**City of Bellevue
Development Services Department
Land Use Staff Report**

Proposal Name: Enatai Short Plat

Proposal Description: Preliminary Short Plat approval to subdivide an existing parcel into two single-family lots within the R-5 zoning district.

File Number: 18-123987-LN

Figure 1 – Preliminary Short Plat Proposal

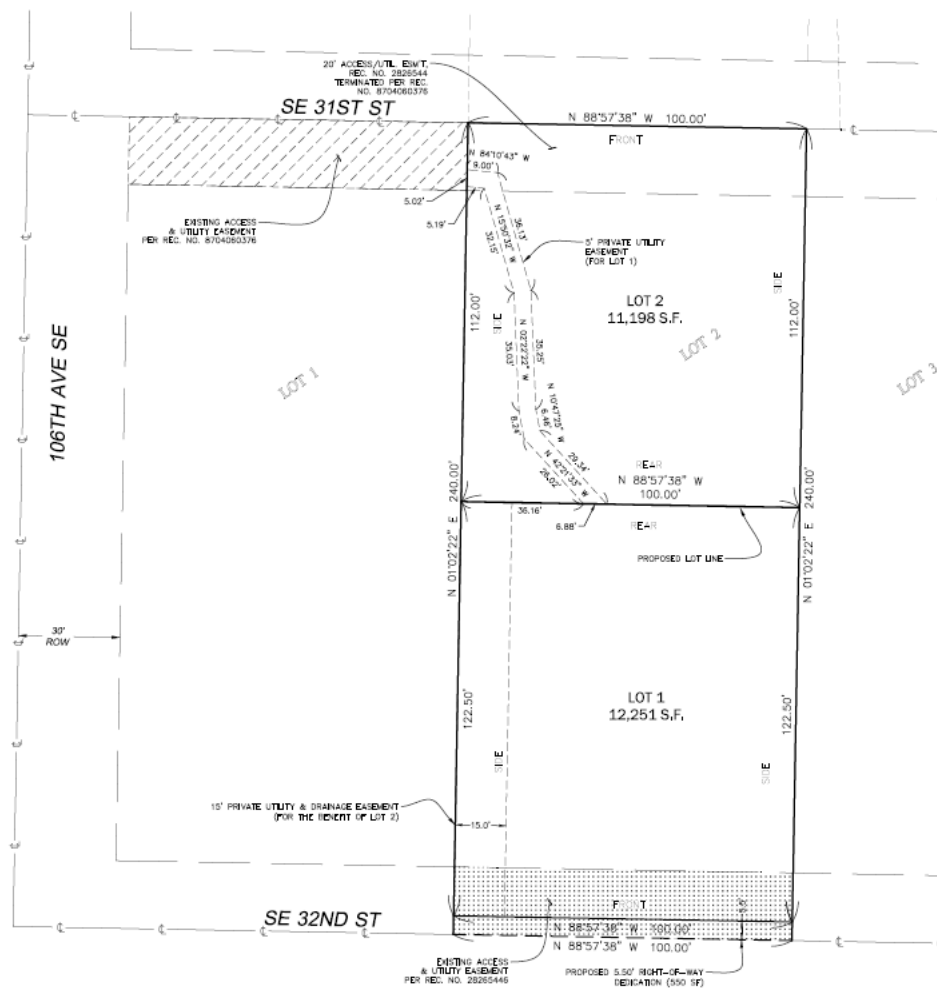
- Dedicate 5.5 feet of Right-of-Way along SE 32nd Street to accommodate the existing public road width.
- Install a minimum 10-foot-wide single-family driveway approach on SE 32nd Street.
- Construct improvements to the single-family driveway on 106th Avenue SE to provide a minimum 10-foot-wide driveway.
- Sight distance requirements must be met per BCC 14.60.240 at both single-family driveways.

The original design was revised from 3 lots down to 2 lots and tree retention was revised and increased from originally proposed.
